BULLETIN: BU-133 MC

MAIN BOOM ROCKER SHAFT FOR ROUND-UP RIDES MANUFACTURED BY FRANK HRUBETZ & CO., INC. AND KILINSKI MFG. CO.

MAN-CO MFG., INC. BULLETINS

30' ROUND-UP - SHAFTS AND SPINDLE REPLACEMENT

MAN-DO: MFG. INC. 720, BOX 13114 SALEM, OR 97309
 CYL. ANCHOR SHAFT
 DATE 8-31-89
 DRAWN BY SWJ
 SCALE

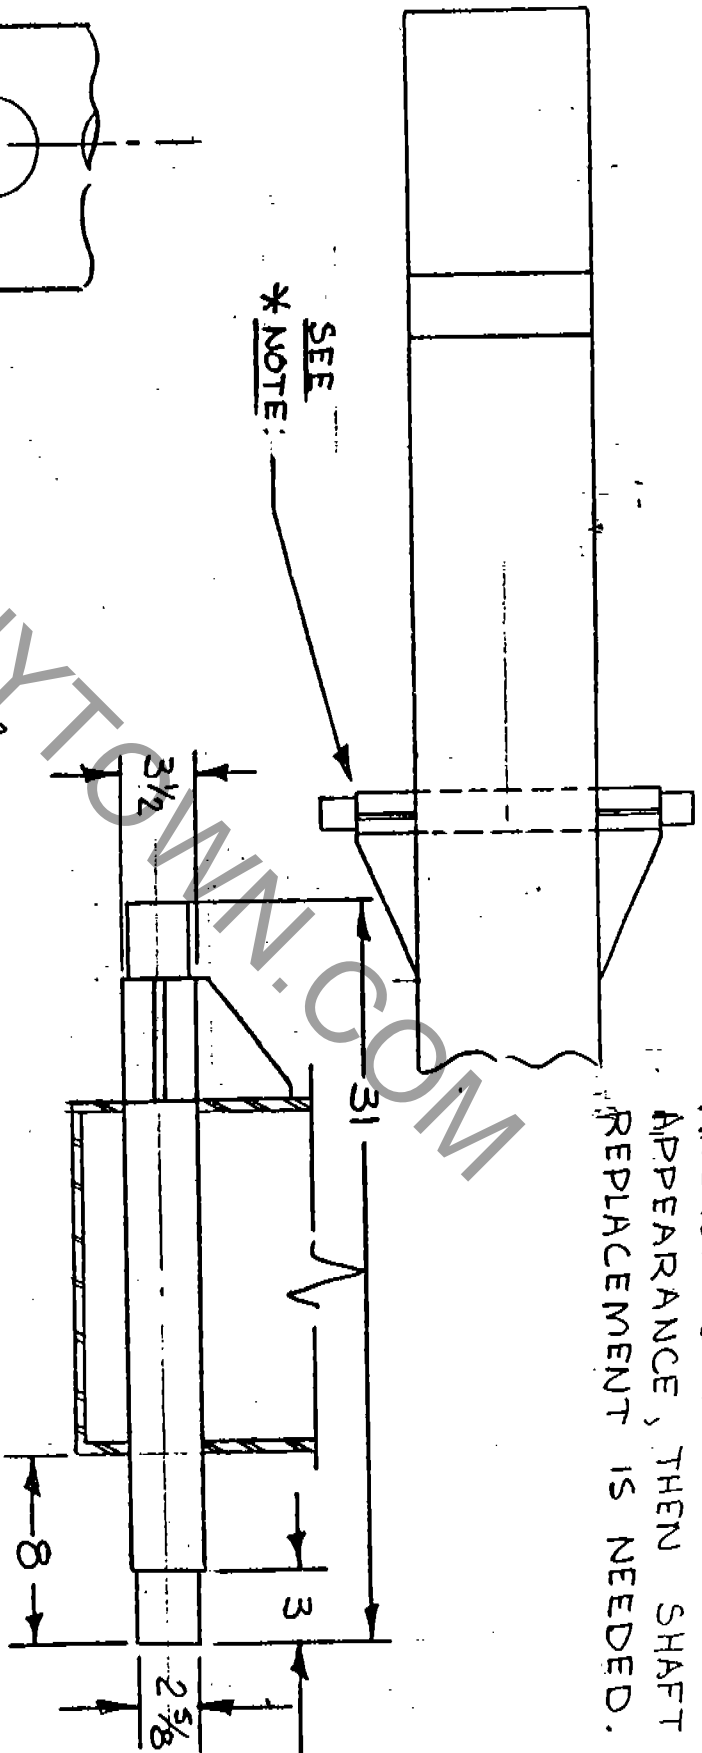
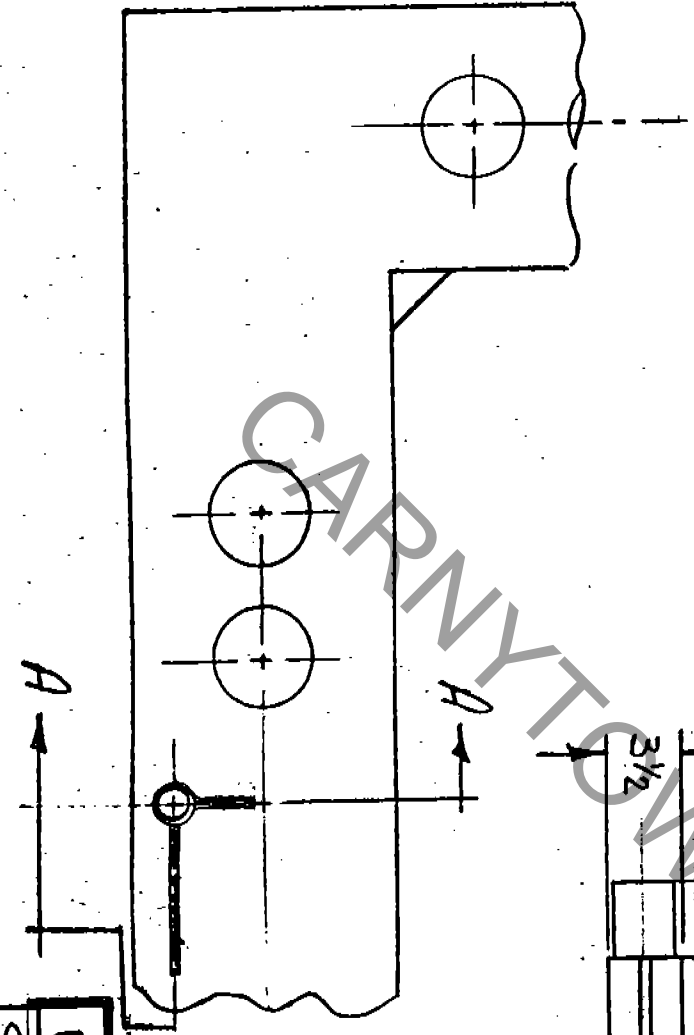
* NOTE: IF CYLINDER ANCHOR SHAFT HAS THIS APPEARANCE, THEN SHAFT REPLACEMENT IS NEEDED.

MAIL ROOM ROCKER SHAFT

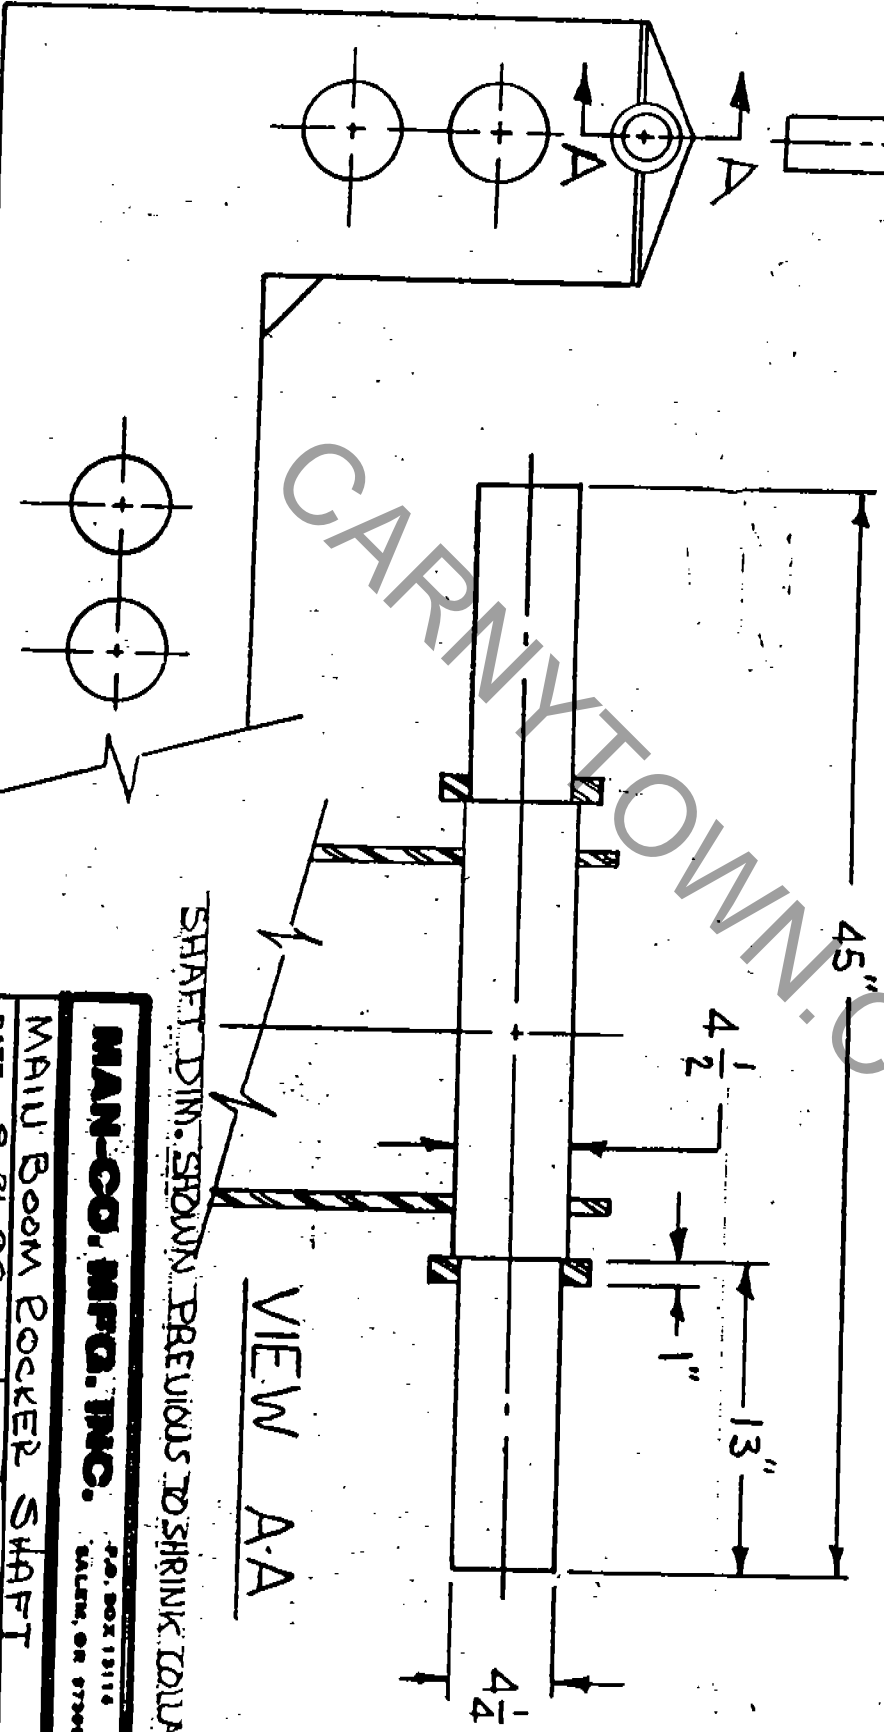
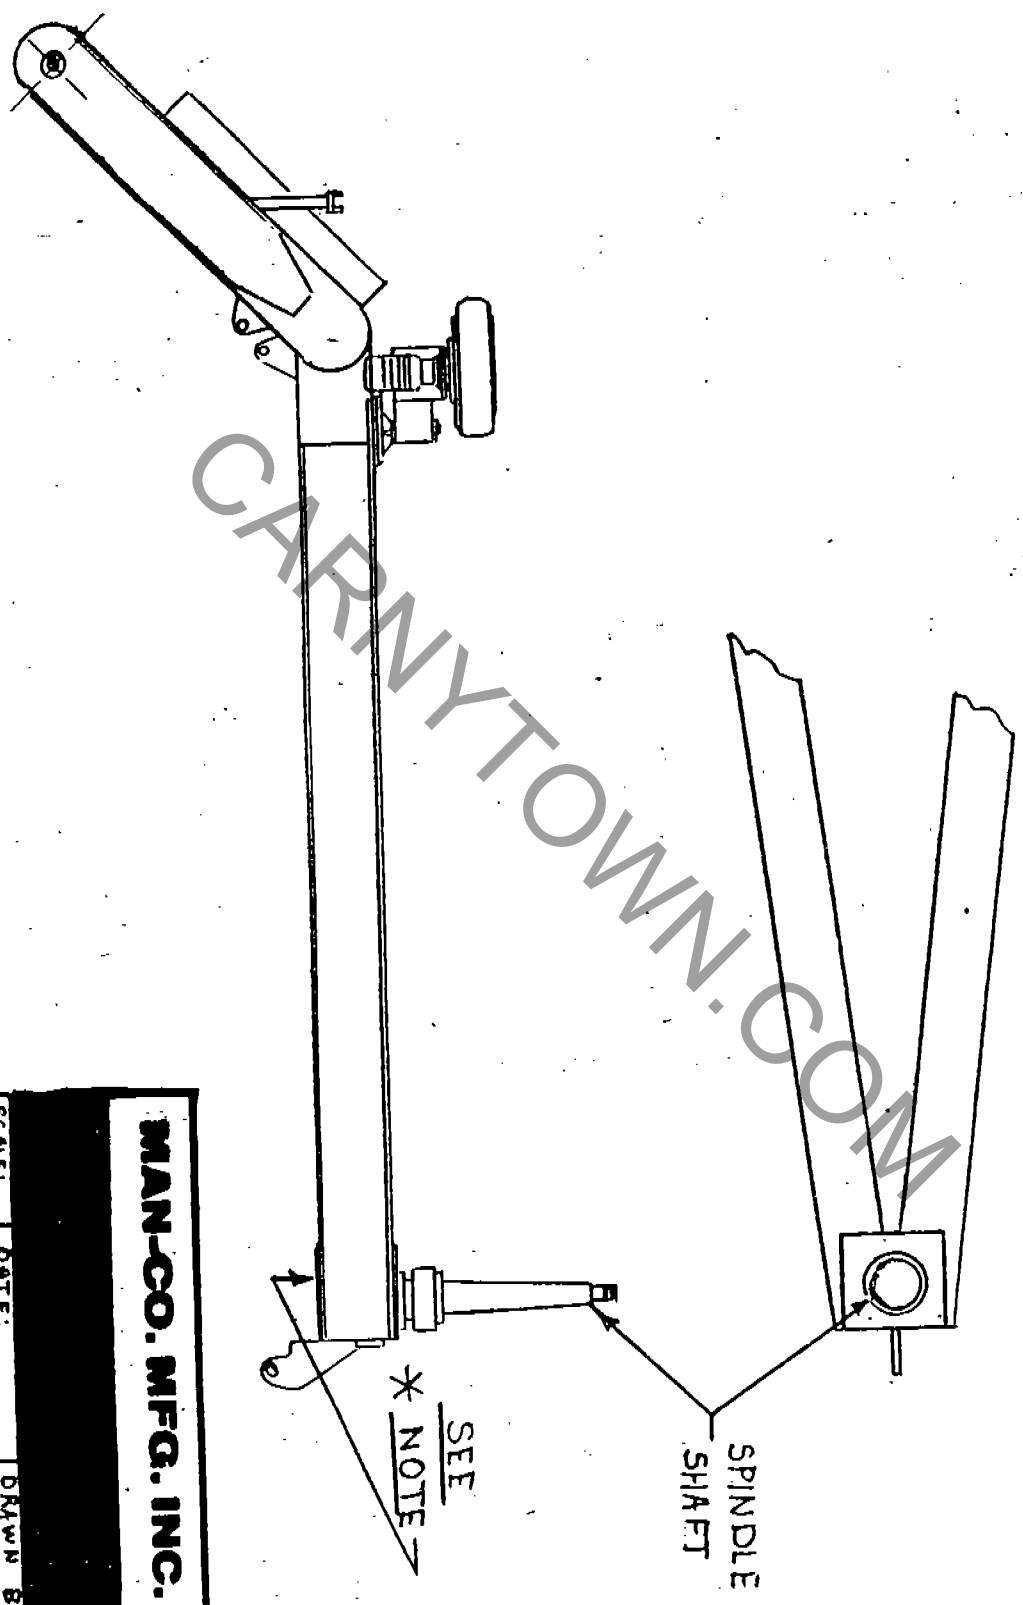
* NOTE: IF ROCKER SHAFT HAS THIS APPEARANCE THEN REPLACEMENT OF SHAFT IS NEEDED.

FIREBALL SPINDLE SHAFT

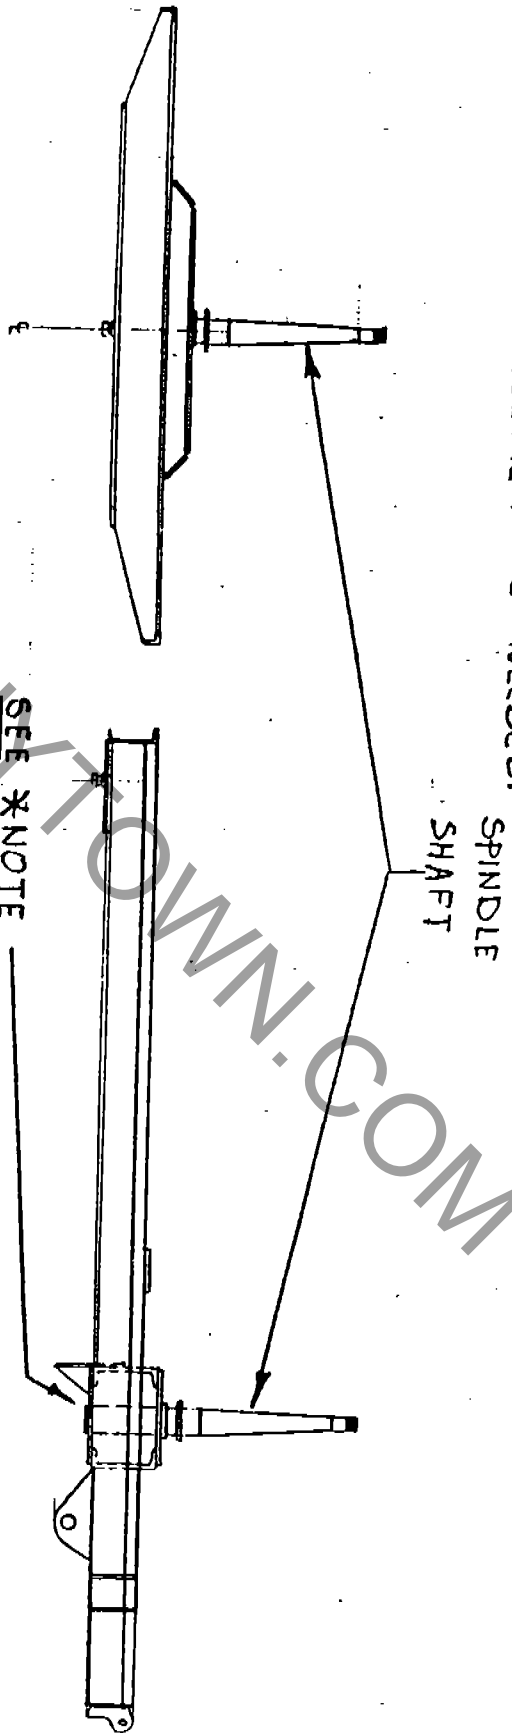
*NOTE: IF NO SHRINK COLLAR IS VISIBLE AT THIS POINT THEN SPINDLE SHAFT REPLACEMENT IS NEEDED.

SPINDLE SHAFT ON BOOM

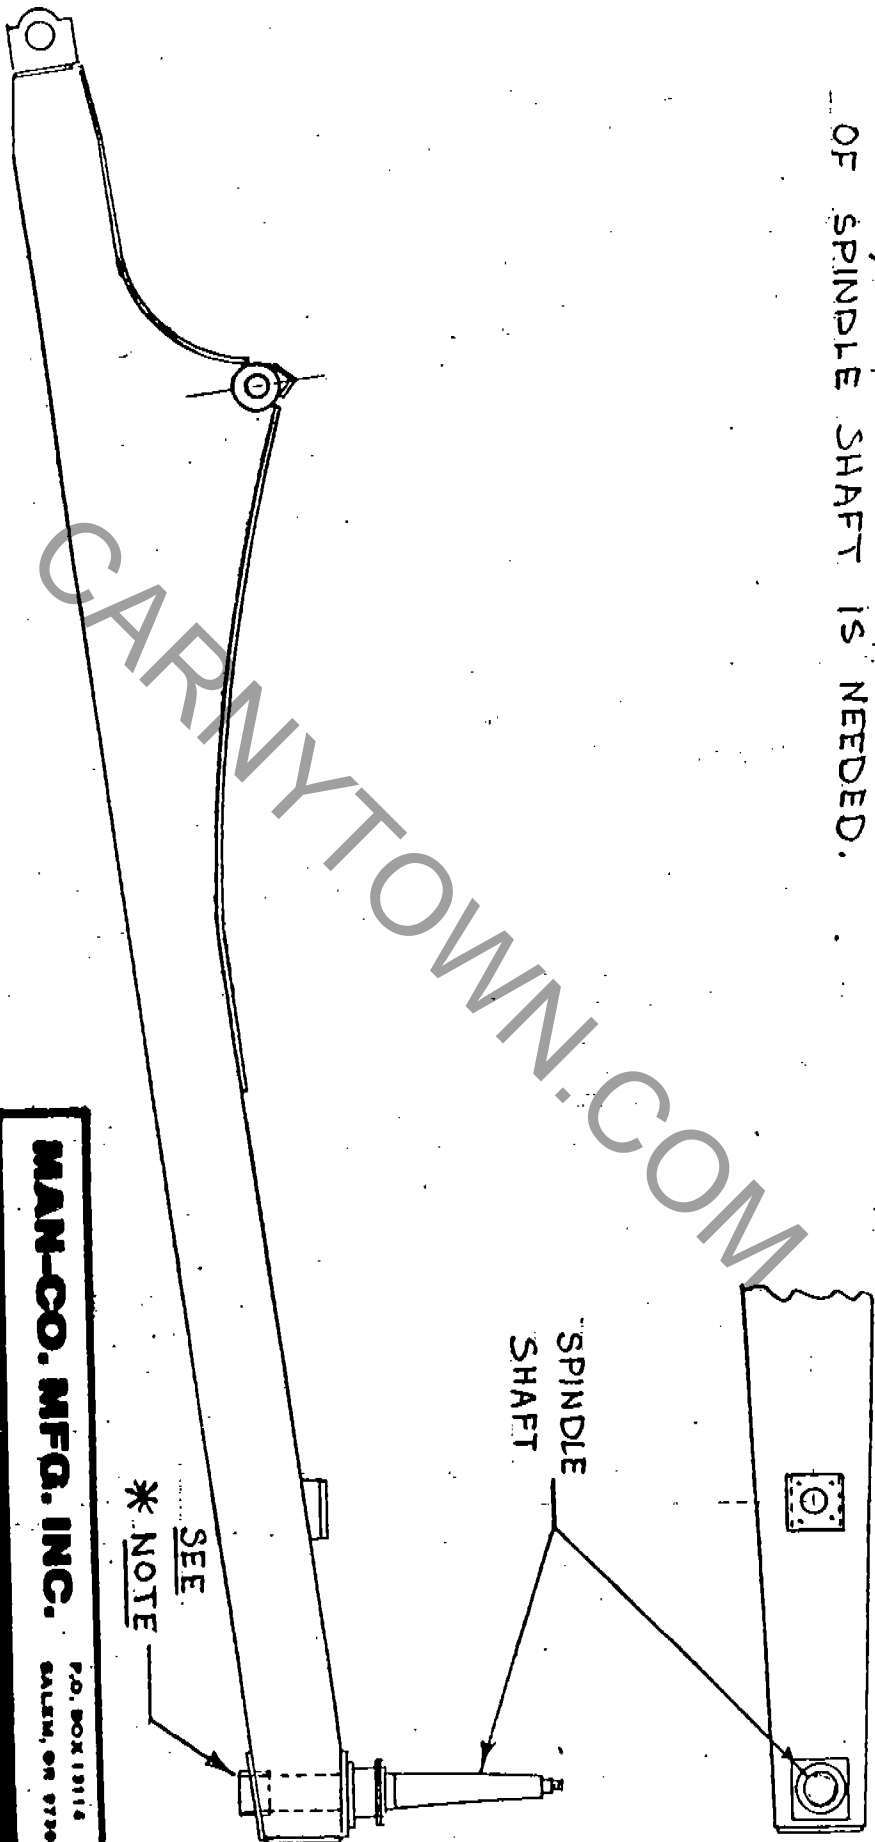
* NOTE: IF NO SHRINK COLLAR IS VISIBLE AT BOTTOM OF BOOM, THEN REPLACEMENT OF SPINDLE SHAFT IS NEEDED.
